# TOWN OF OAK BLUFFS STREETSCAPE MASTER PLAN DESIGN PROJECT

## MASTER PLAN RECONCILIATION REFERENCE SHEETS

# STREETSCAPE DESIGN / MASTER PLAN RECONCILIATION

Concept Plan

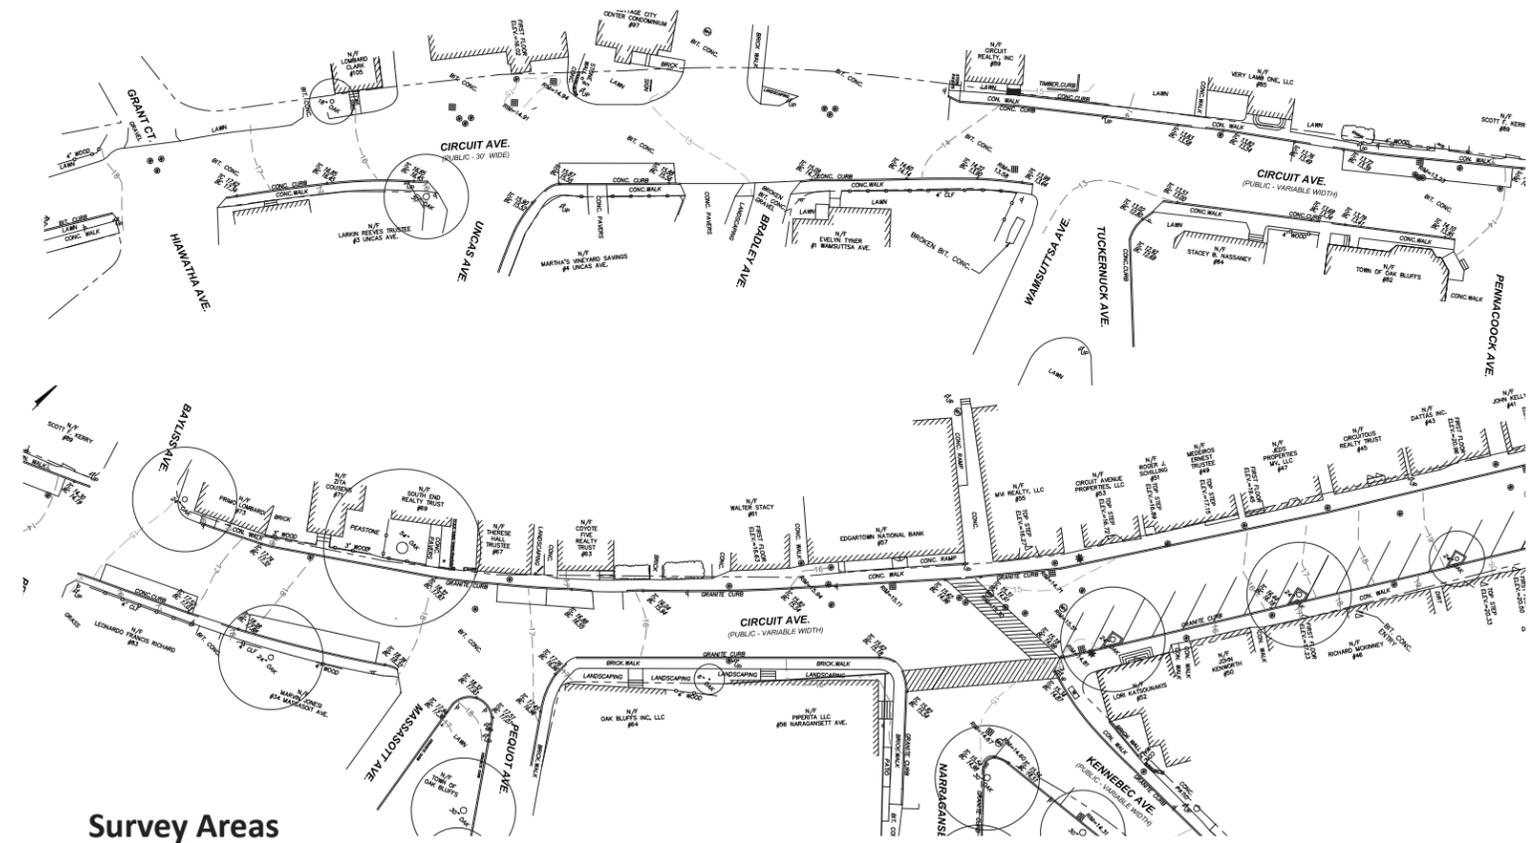
Add 4'W sidewalk on east side of Circuit Ave from #89 to #97. Replace concrete curb with granite. Many proposed street trees are not needed- existing landscaping is sufficient. Niantic Park is currently being renovated, with a sidewalk connection to Circuit Ave.

Because master plan is very schematic, we should make a more detailed concept plan sketch of area, to give better definition to locations of improvements and new trees.

# CIRCUIT AVE & KENNEBEC AVE INTERSECTION

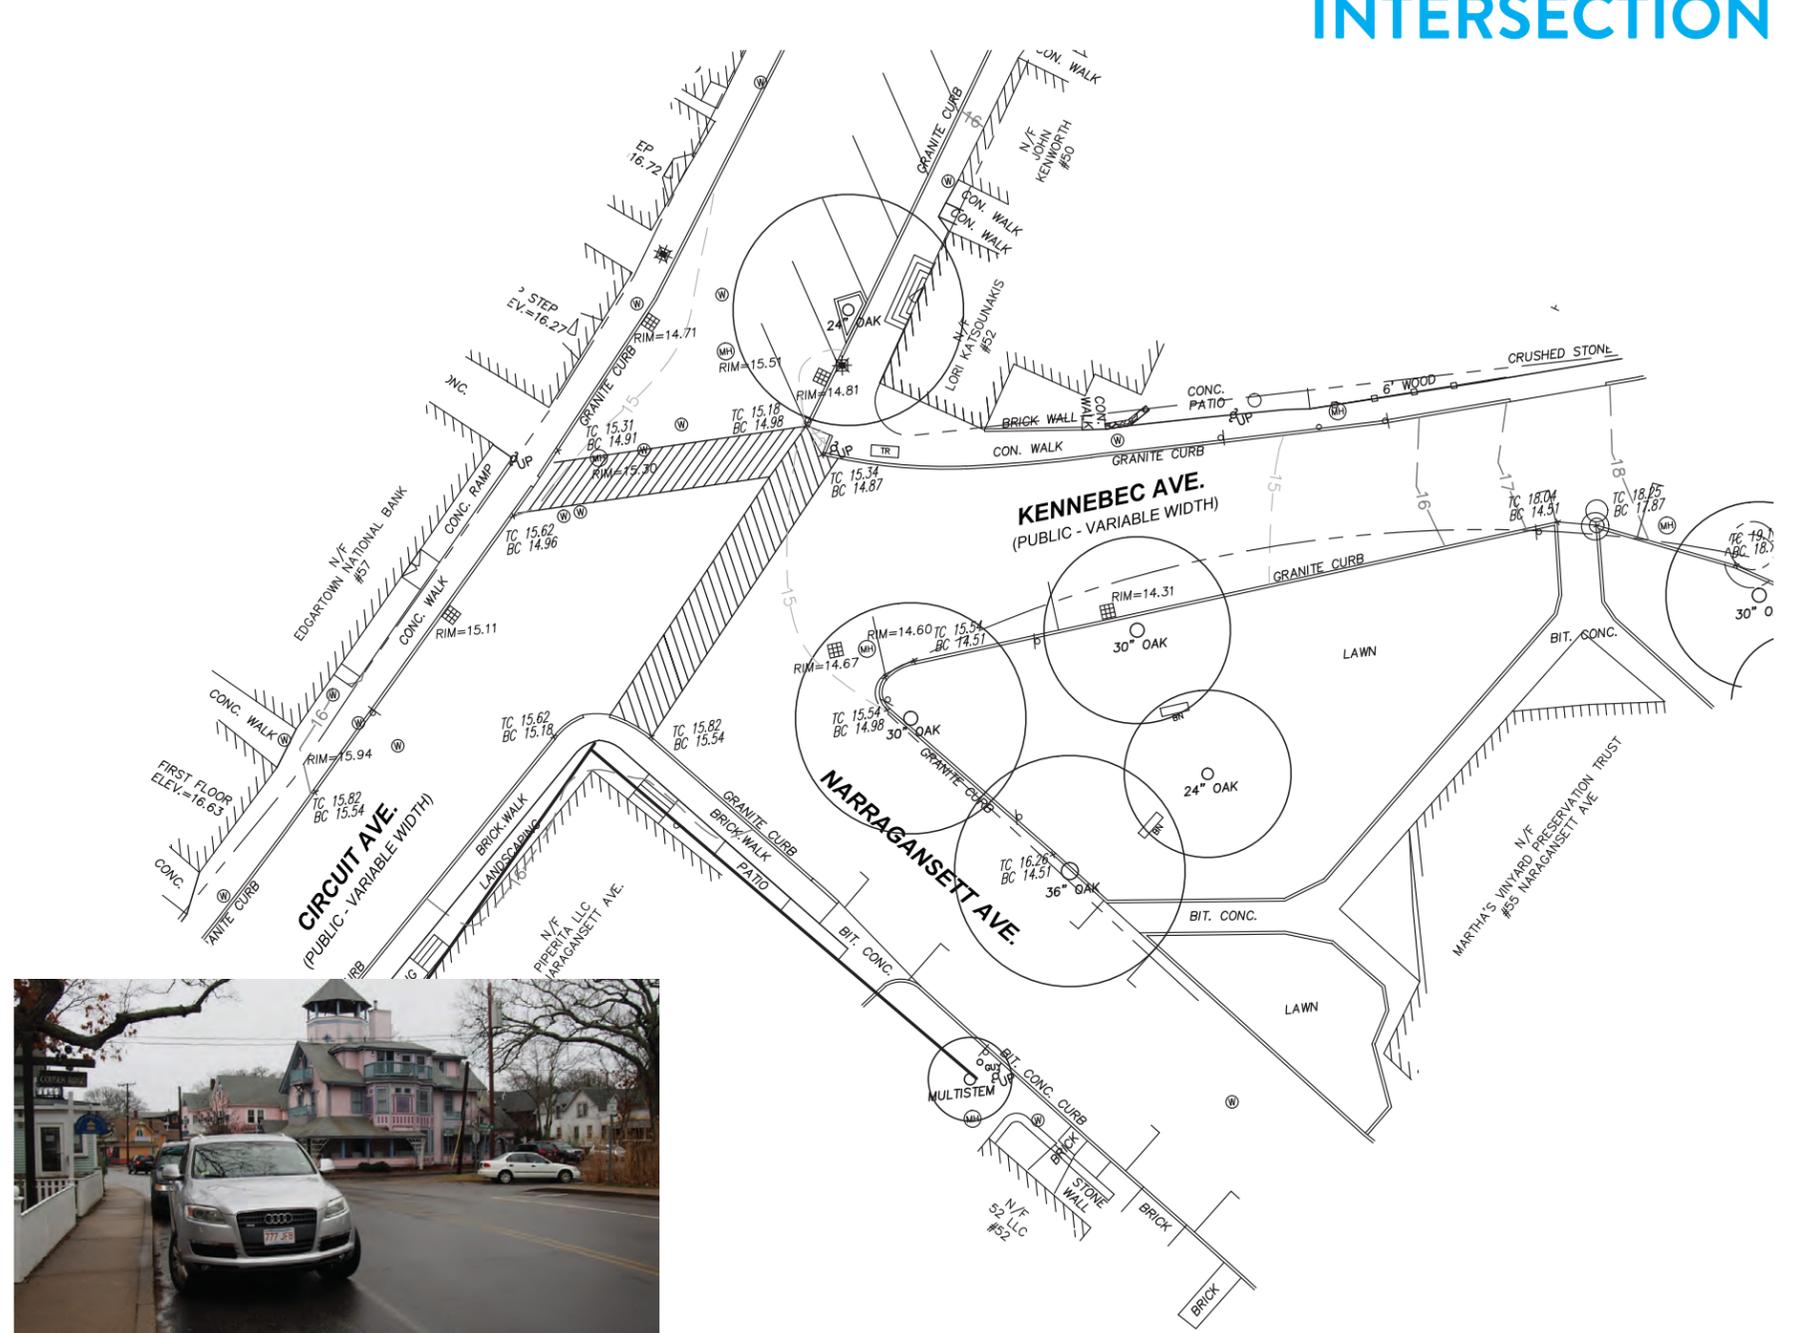
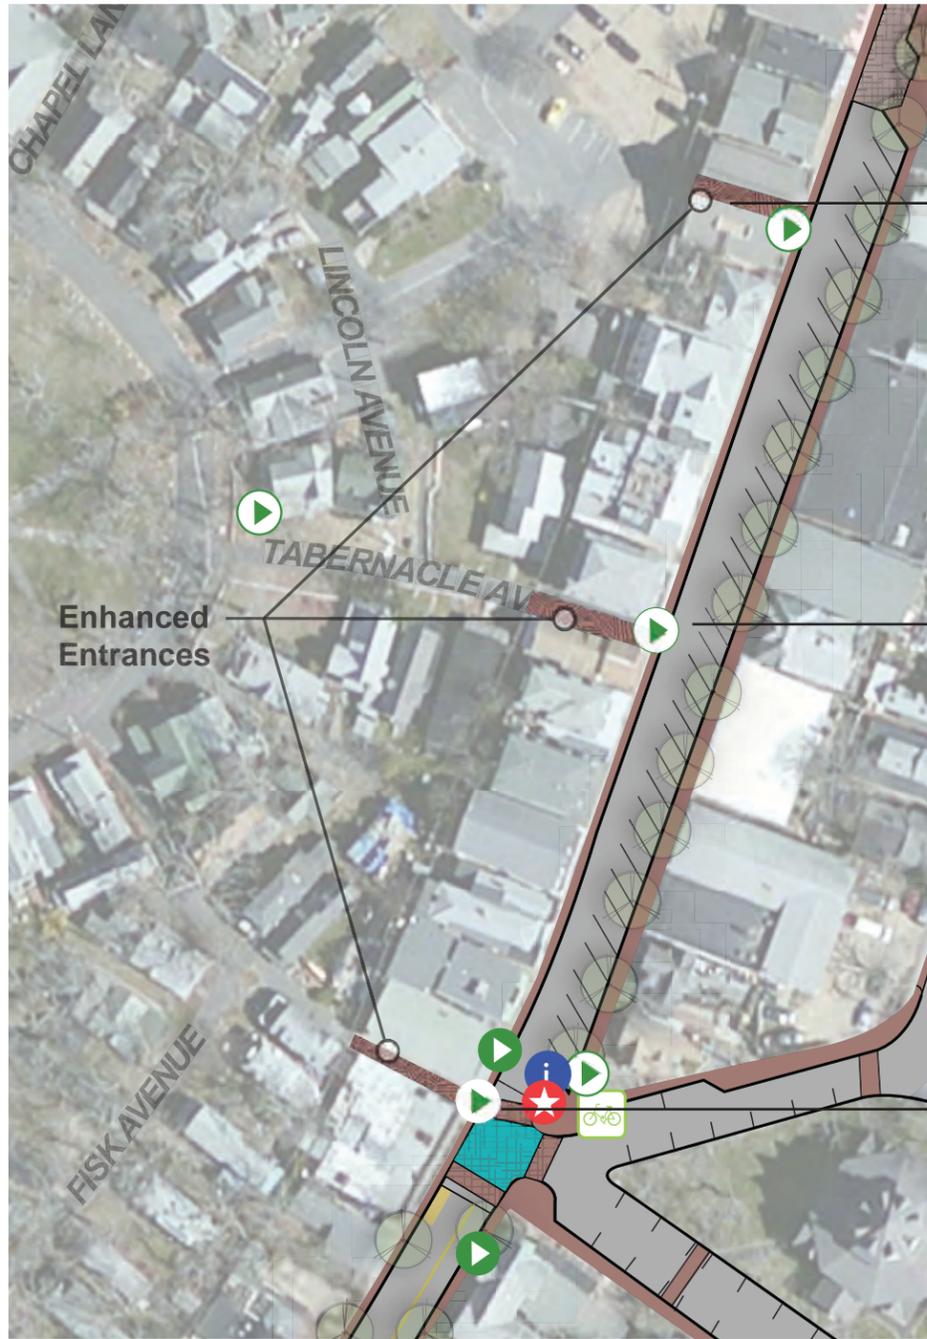
**Analysis**  
 Ample room for bumpouts and pocket plazas. Can extend sidewalk along Narragansett Ave to Grove Ave and narrow roadway to ~20' W. Can add 2 parkings spaces and widen sidewalk on Kennebec Ave.

**Recommendation**  
 Master plan concept sketch can be incorporated into DD design.

Existing Entrance Areas

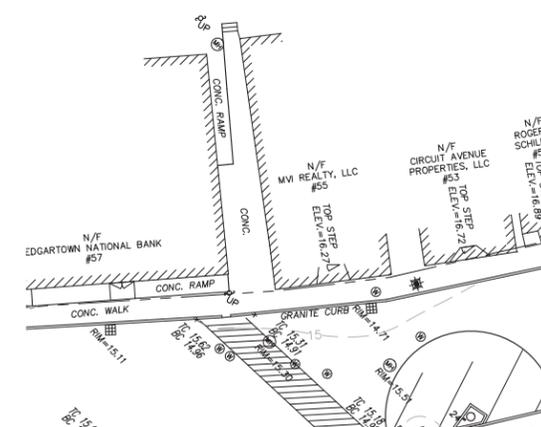
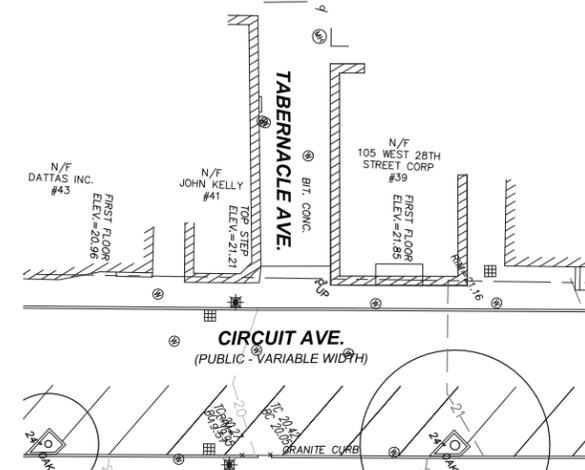
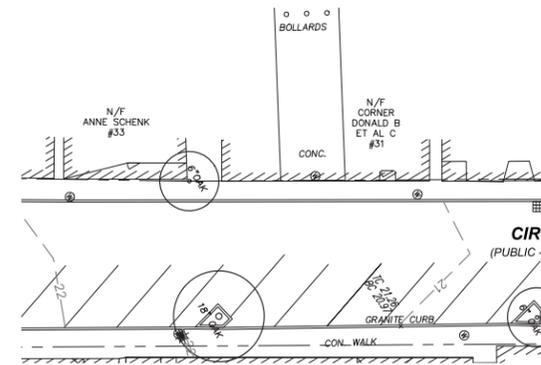
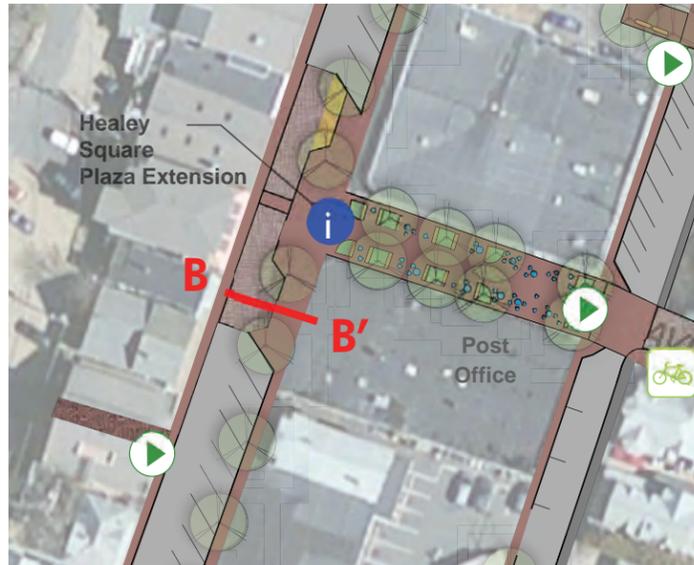
**Analysis**  
 Entrances can be better marked and enhanced with streetscape improvements.

**Recommendation**  
 Master plan concept sketch can be incorporated into DD design.  
 Make concept perspectives of renovated alleys to show to public and property owners.

Pedestrian extension into Circuit Ave

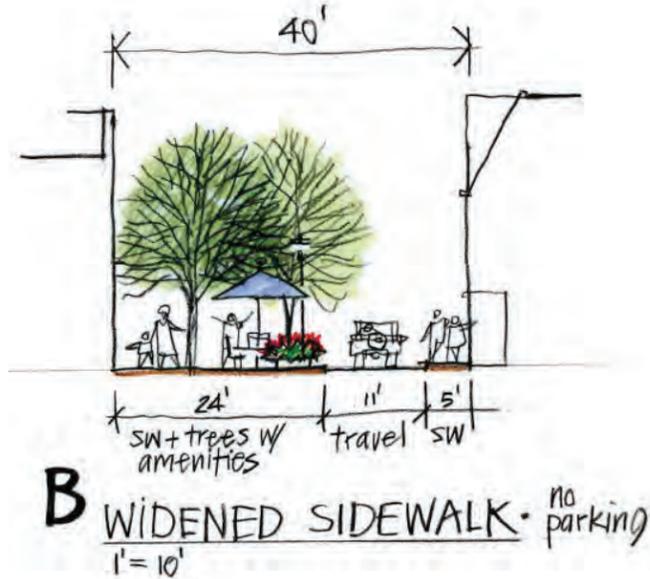
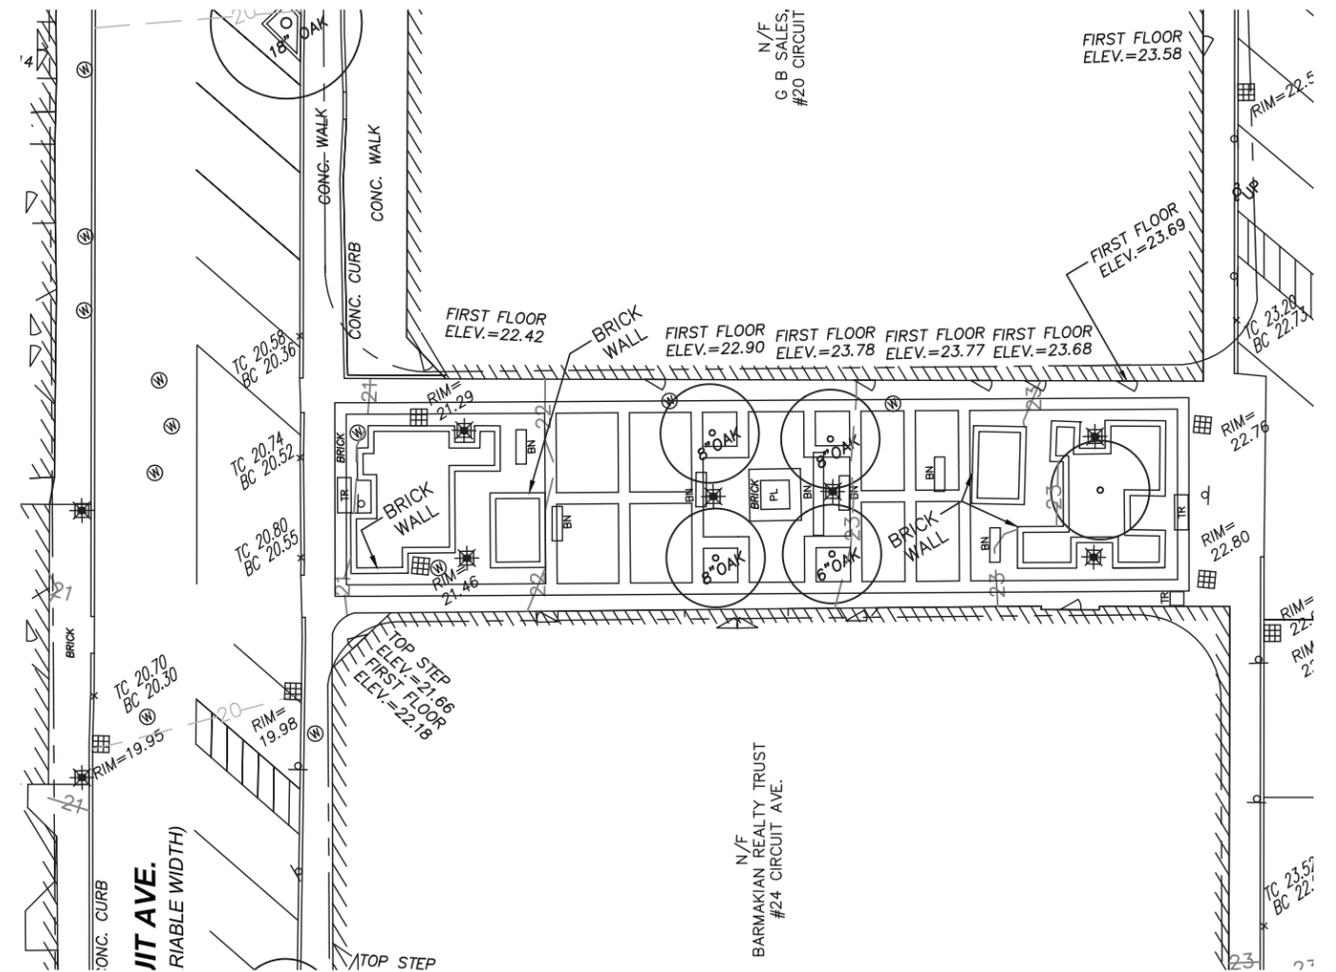
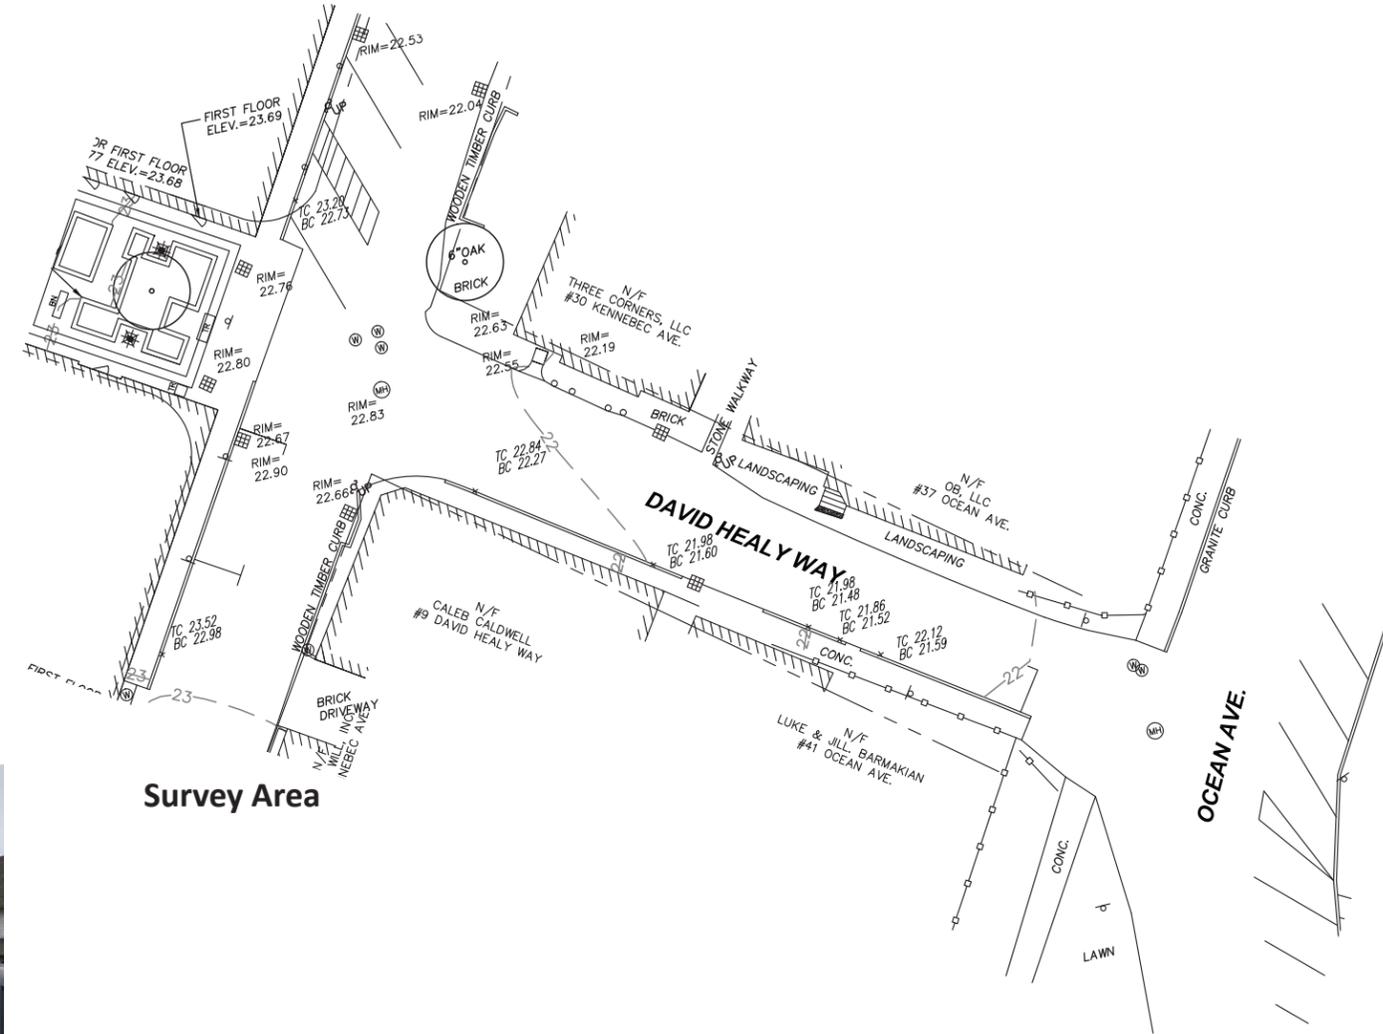
**Analysis**  
 Alley width is about 32'. Can make 5' walkway by buildings, 6' width planters on each side, then 10' walkway through middle. Can reconfigure park while keeping existing oak trees. Can extend plaza into Circuit Ave.

**Recommendation**  
 Master plan concept plan can be incorporated into DD design.

View of David Healey Way from Ocean Park

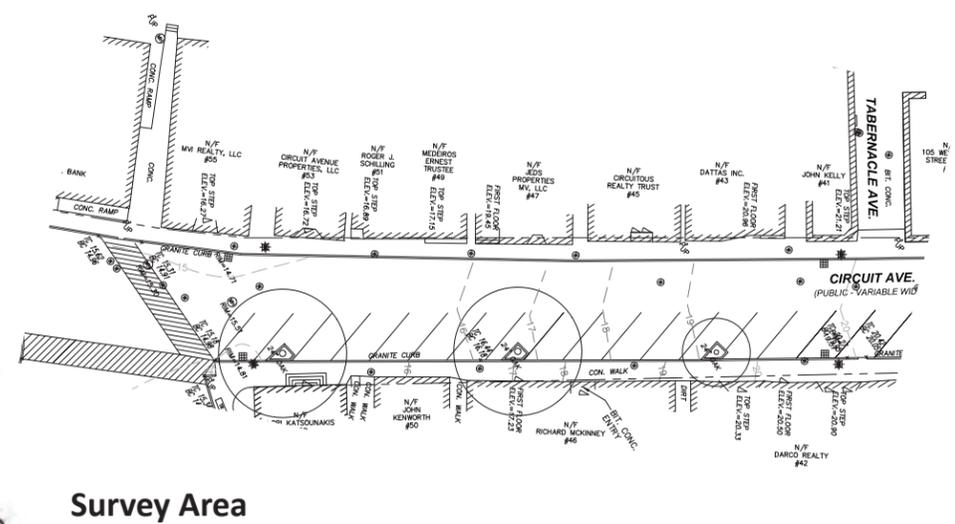
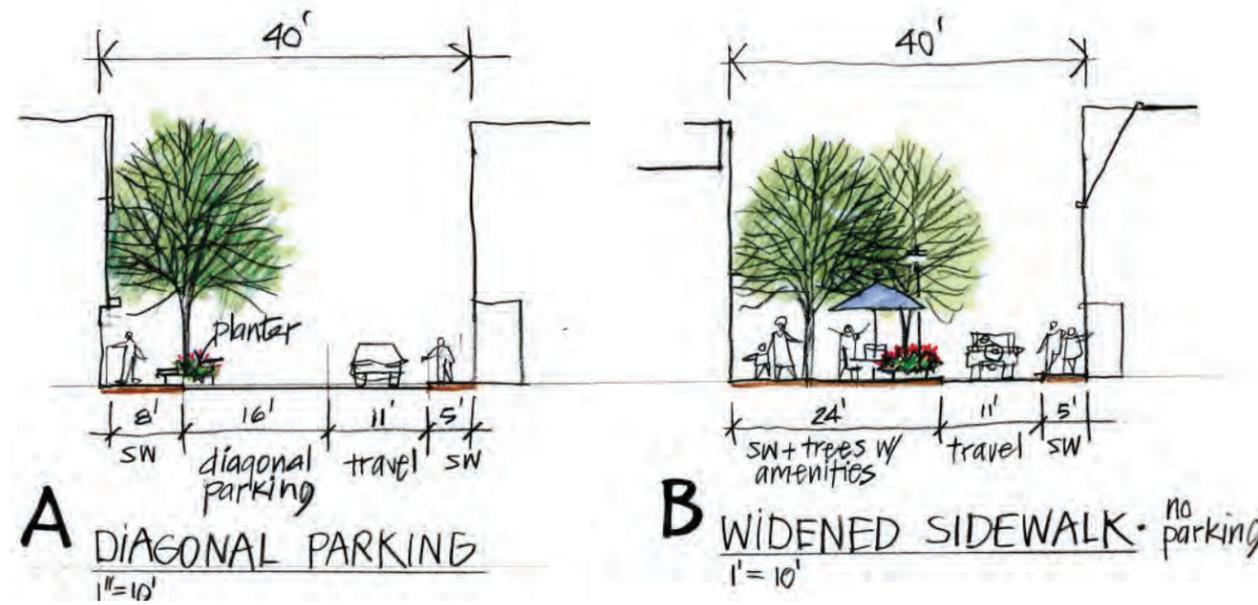
Grades are similar at buildings on both sides of David Healey Way. Can raise roadway to make flush with sidewalk. Can make enhanced crosswalk to Ocean Park walkway.

Master plan concept sketch can be incorporated into DD design.
